MILITARY SPECIFICATION

CABLES, RADIO FREQUENCY, FLEXIBLE AND SEMIRIGID,
GENERAL SPECIFICATION FOR

This amendment forms a part of MIL-C-17G, dated 9 March 1990, and is approved for use by all Departments and Agencies of the Department of Defense.

FIGURE 8. Transmission unbalance."

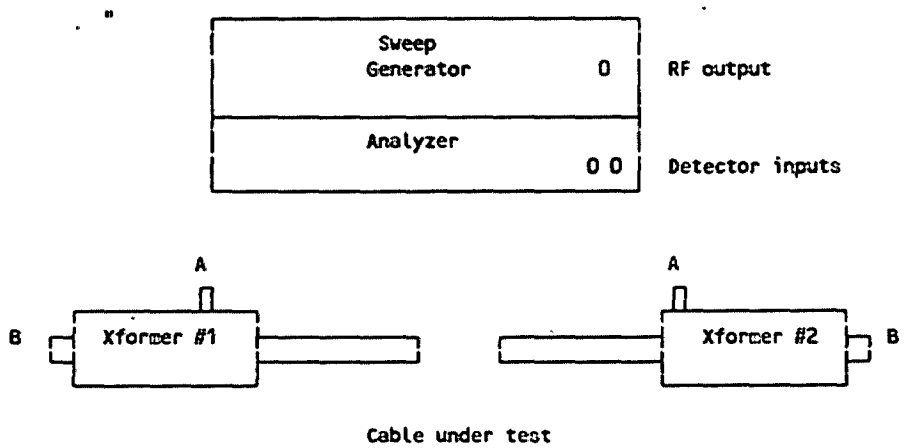
FIGURE 8, delete and substitute new figure 8 as printed below:

Port A and B are series N connectors, remaining two are twinaxial.
